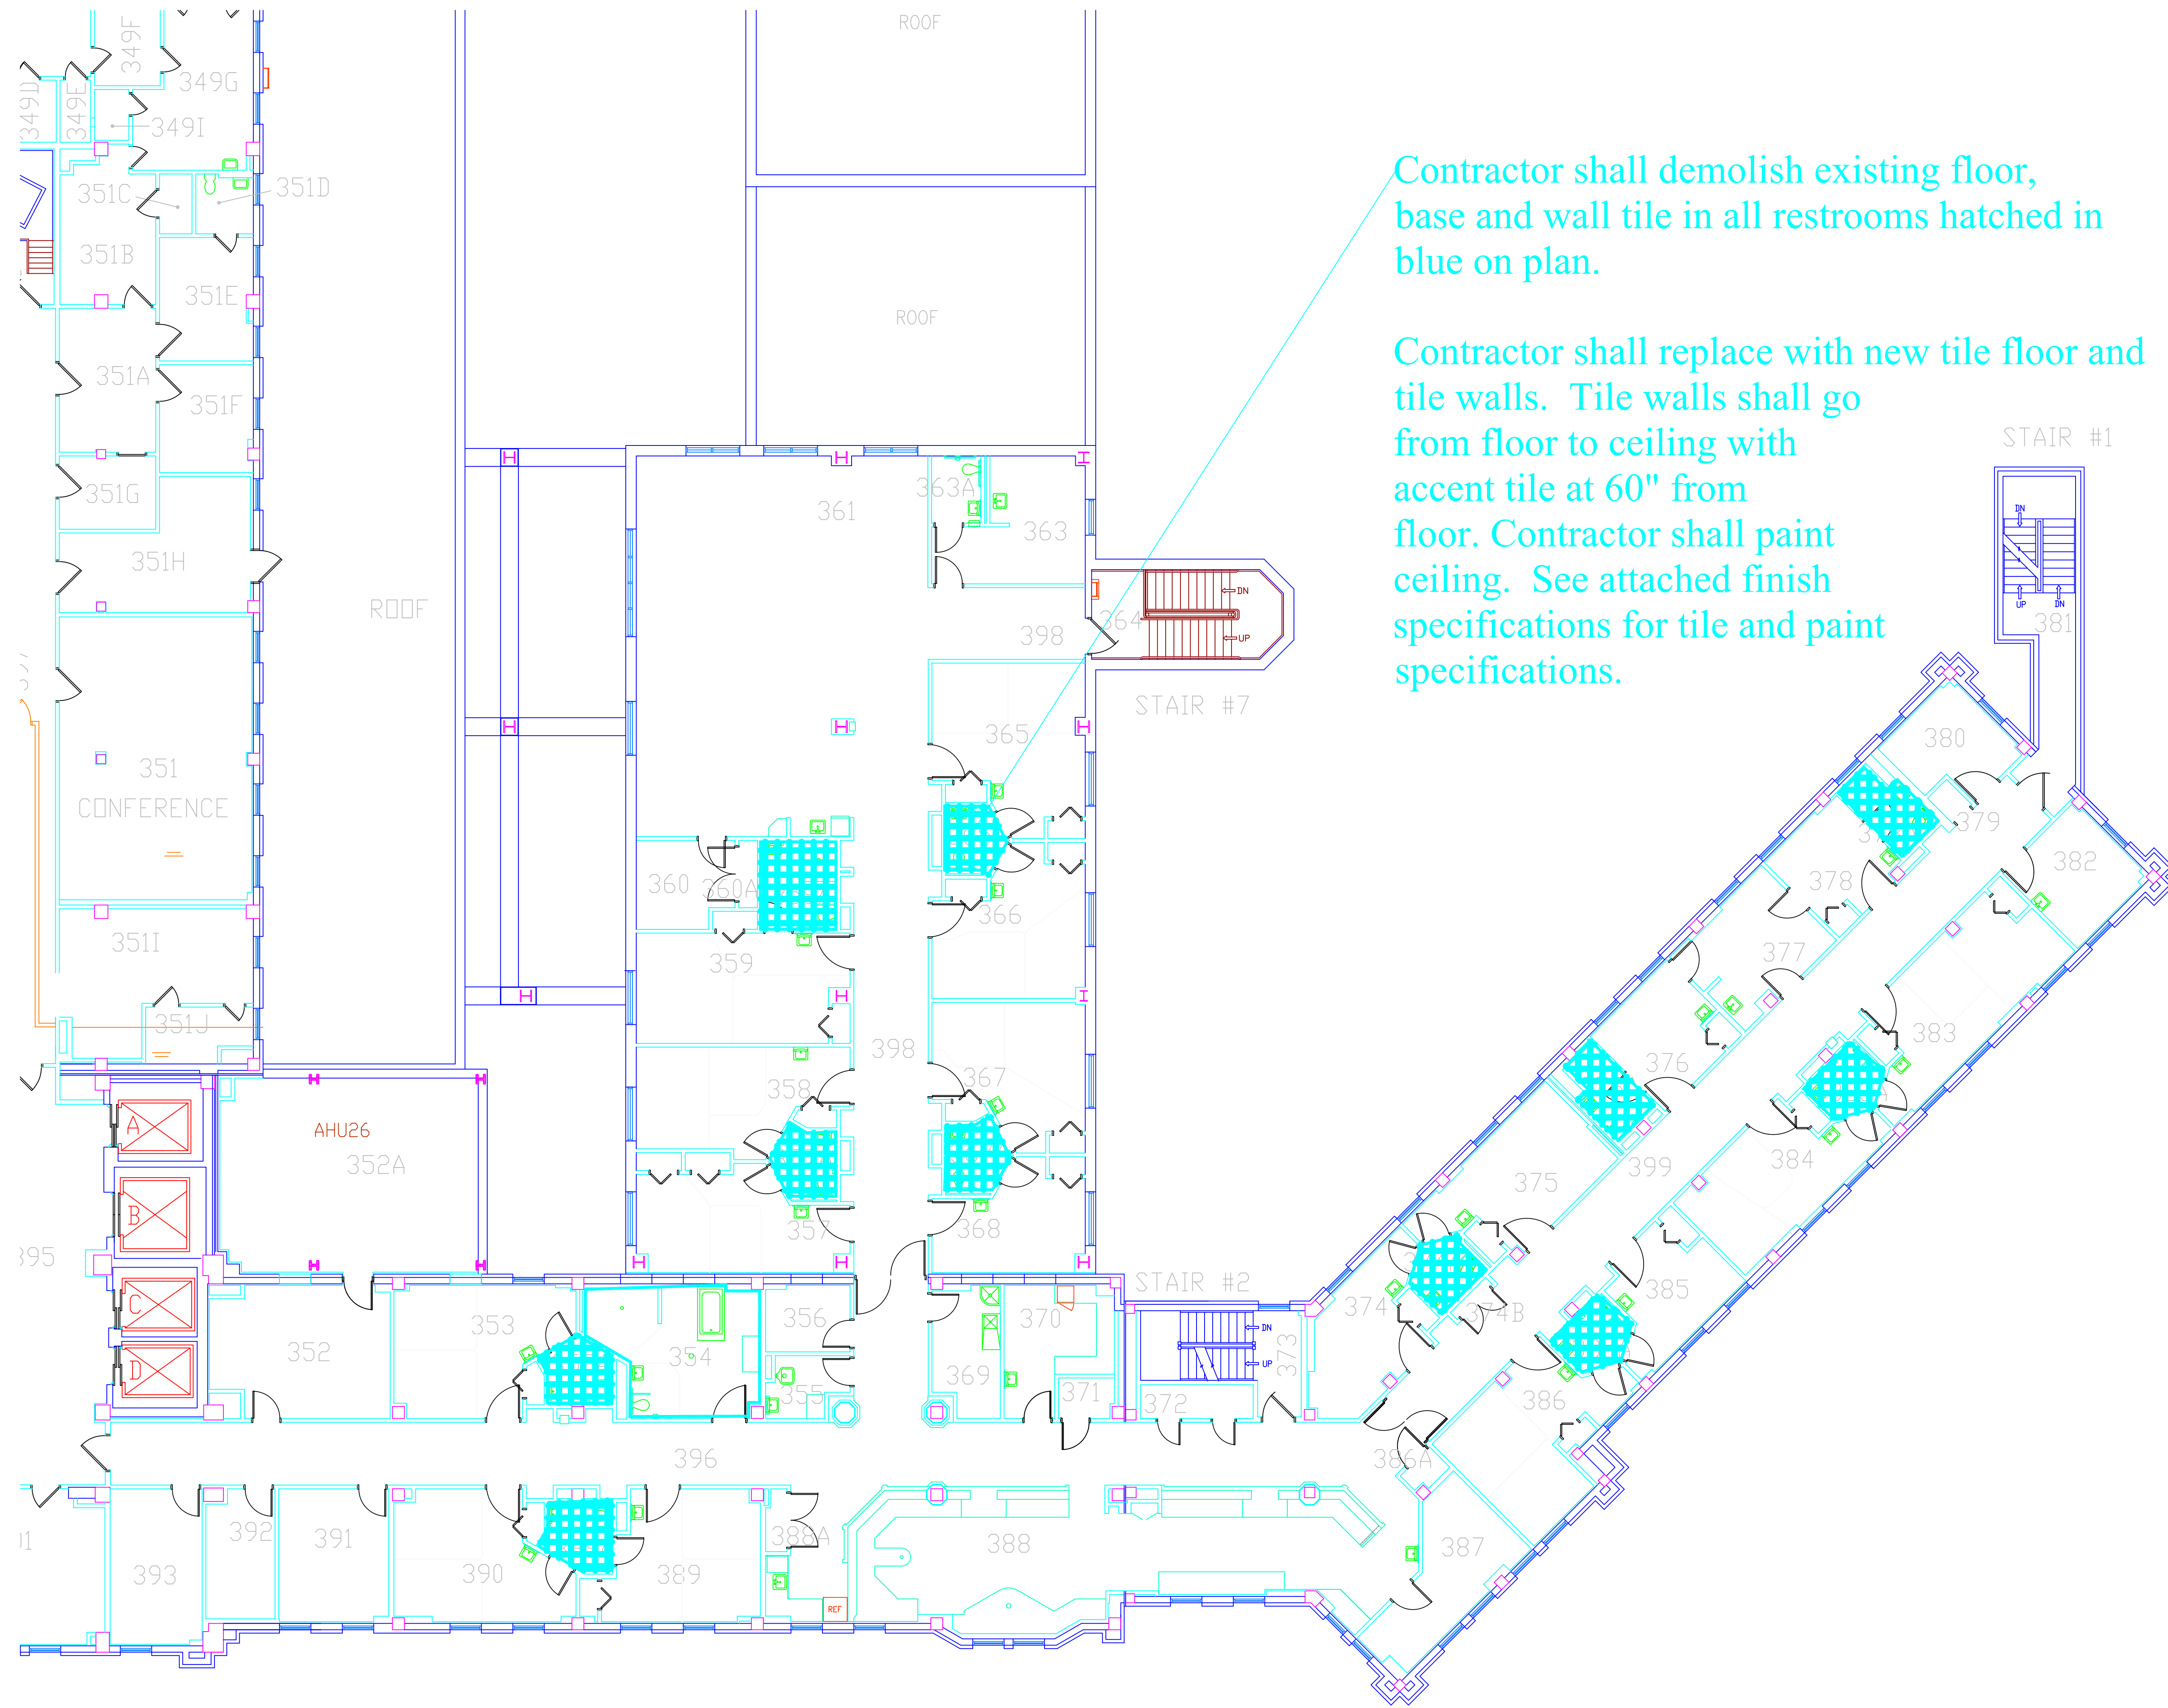
Contractor shall demolish, prep floor, and replace flooring for all inpatient rooms hatched in pink. See attached finish schedule and SOW for flooring specifications and installation requirements.

Contractor shall demolish existing floor, base and wall tile in all restrooms hatched in blue on plan.

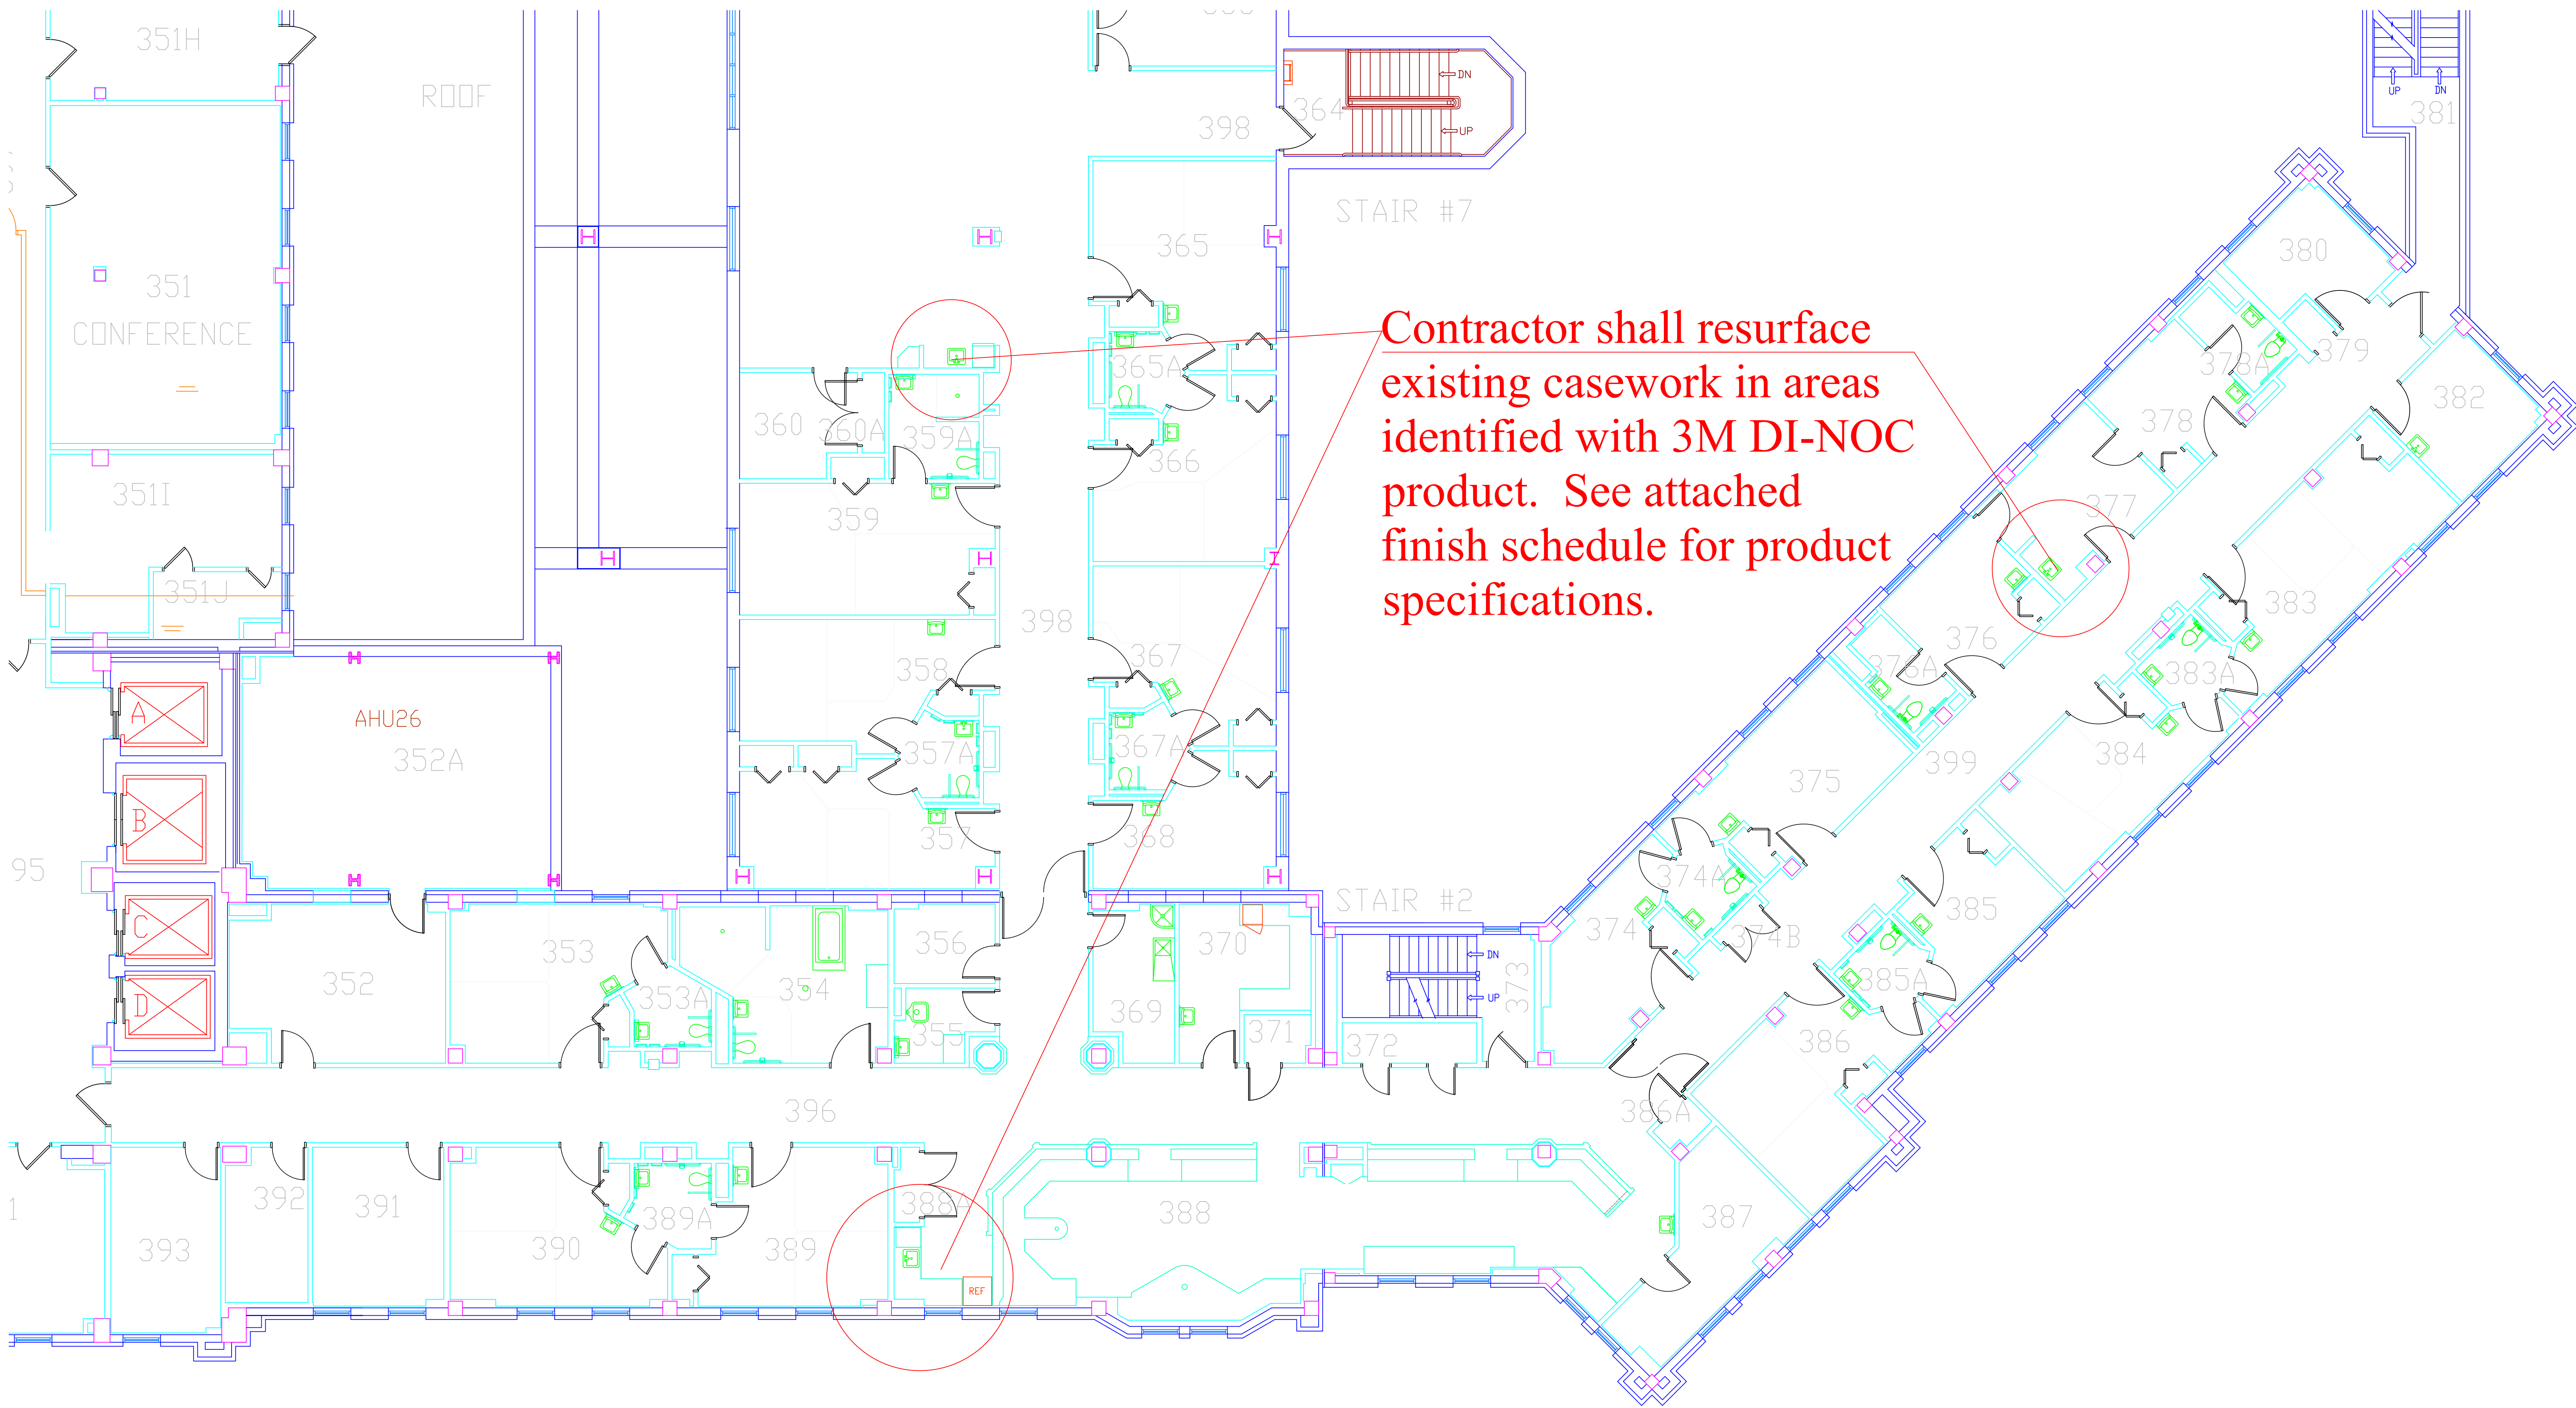
Contractor shall replace with new tile floor and tile walls. Tile walls shall go from floor to ceiling with accent tile at 60" from floor. Contractor shall paint ceiling. See attached finish specifications for tile and paint specifications.

**Contractor shall resurface existing casework in areas identified with 3M DI-NOC product. See attached finish schedule for product specifications.**

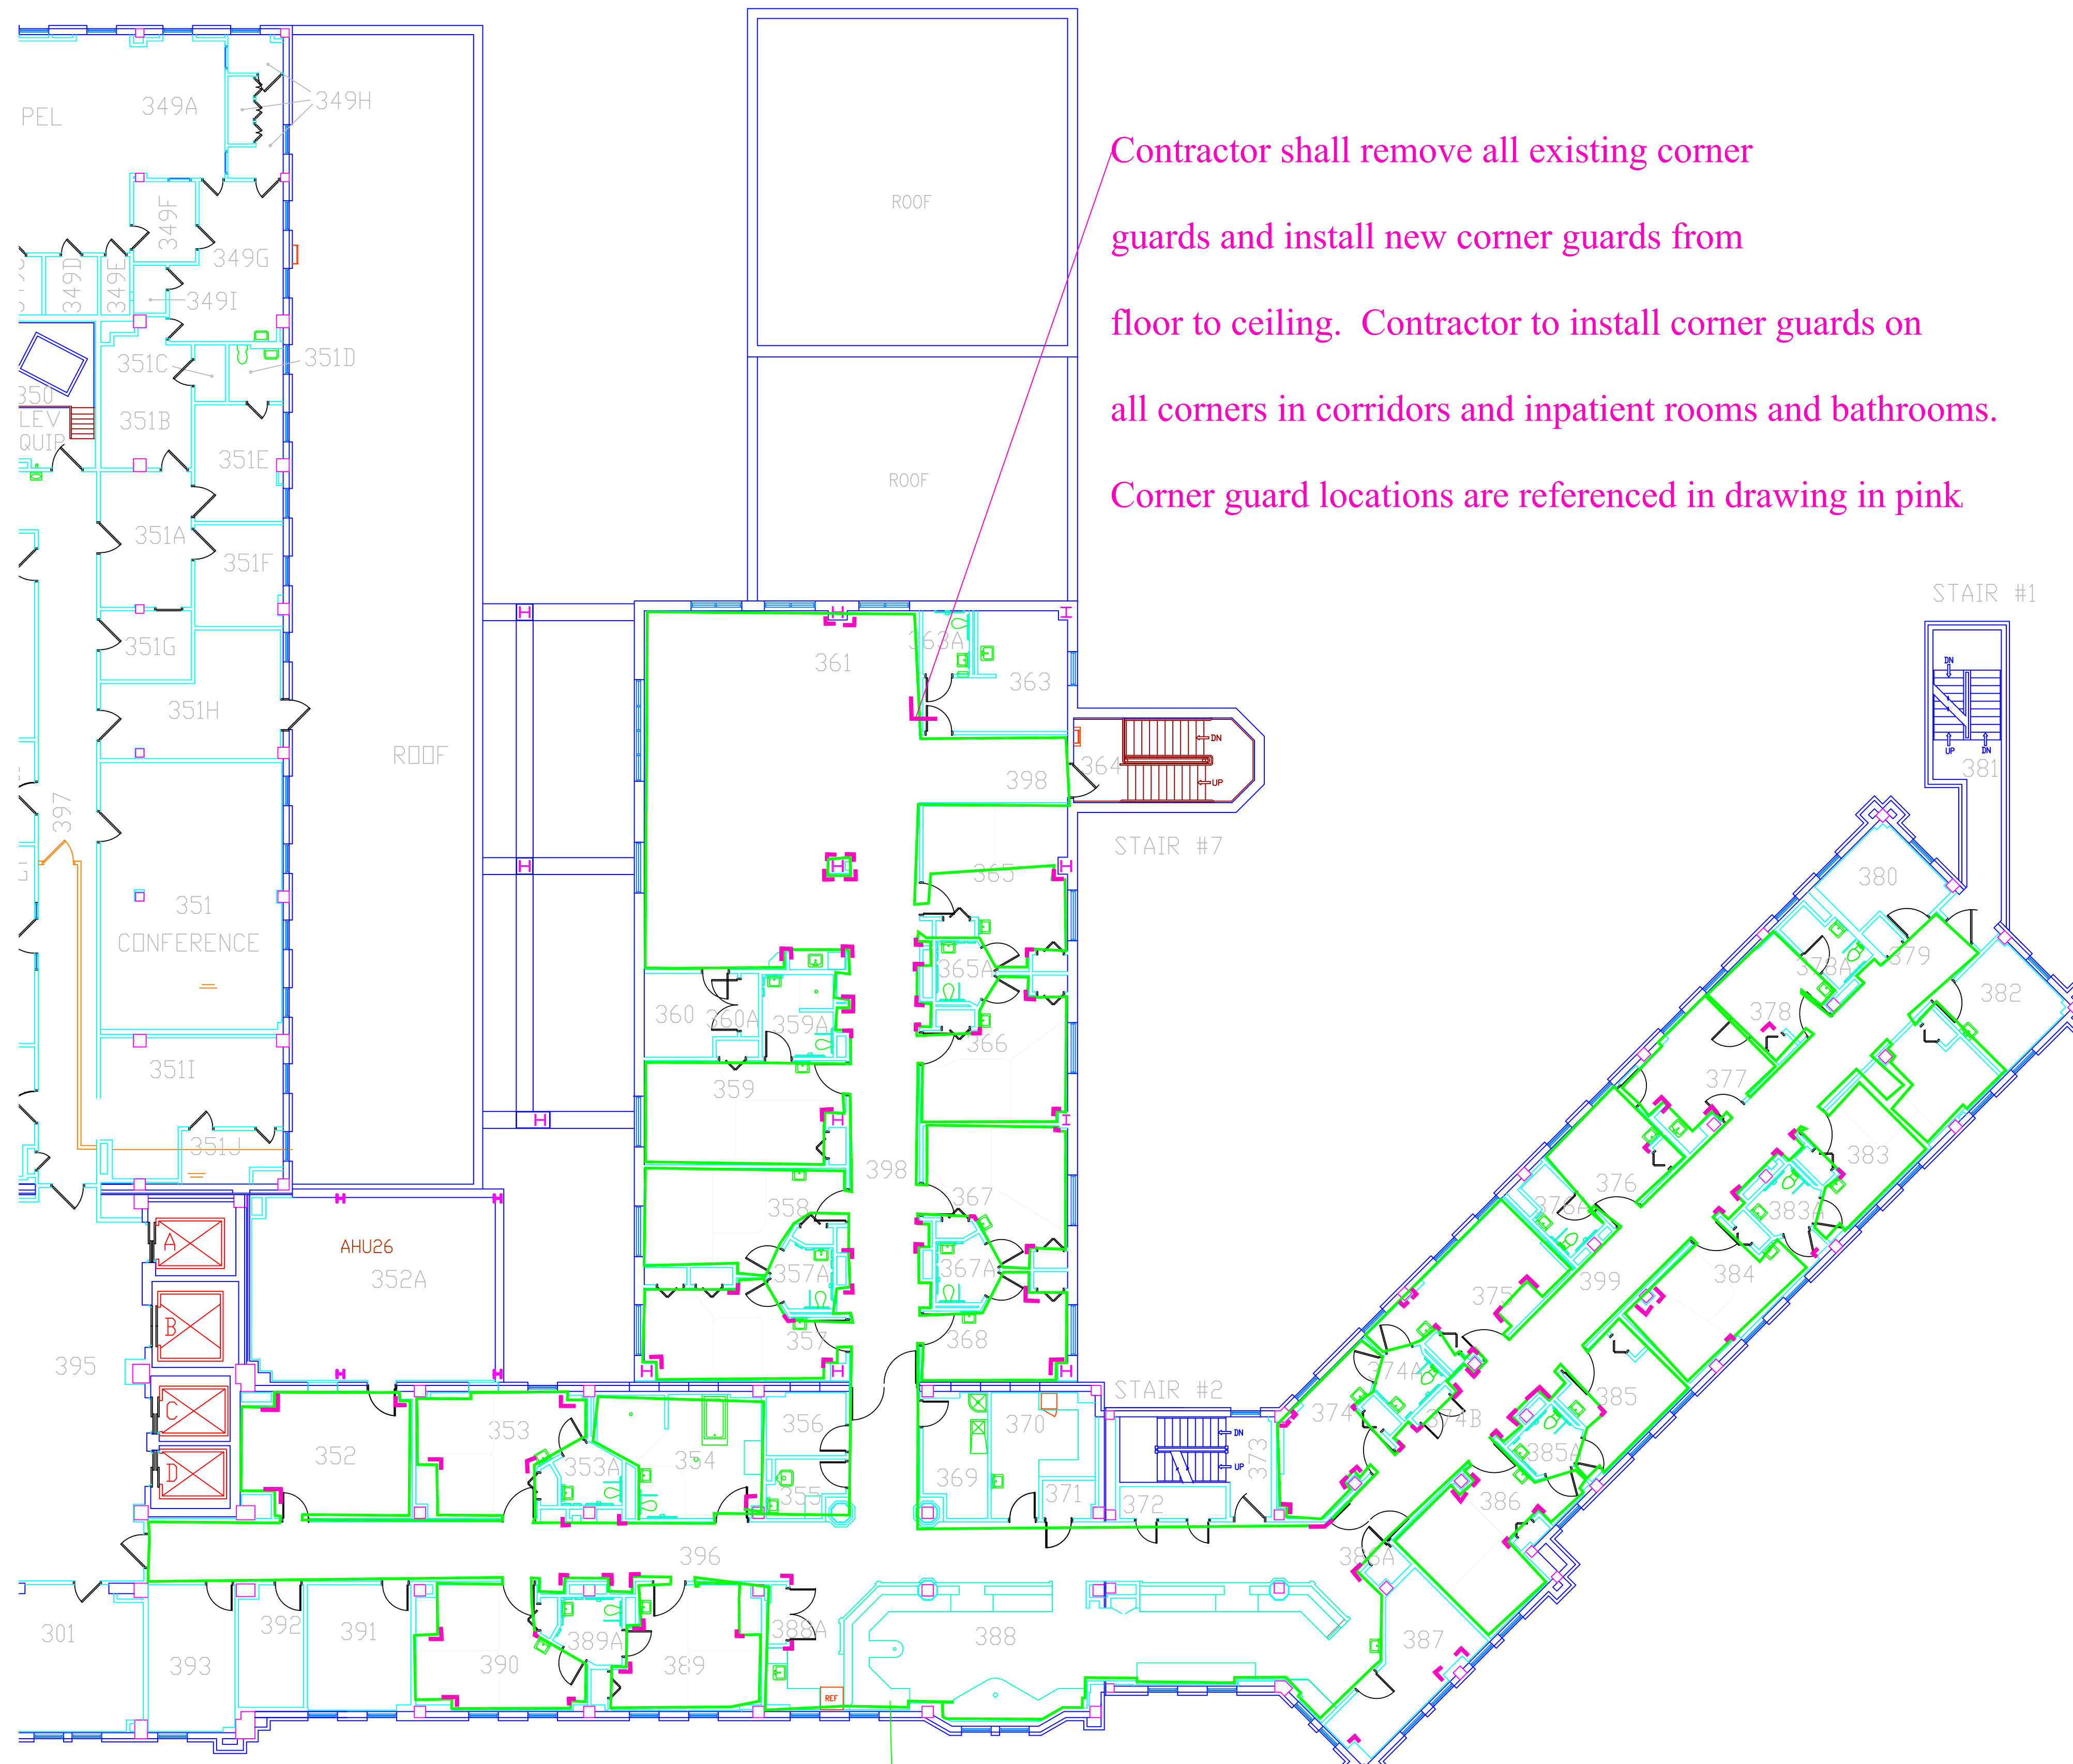
Contractor shall remove all existing corner guards and install new corner guards from floor to ceiling. Contractor to install corner guards on all corners in corridors and inpatient rooms and bathrooms. Corner guard locations are referenced in drawing in pink
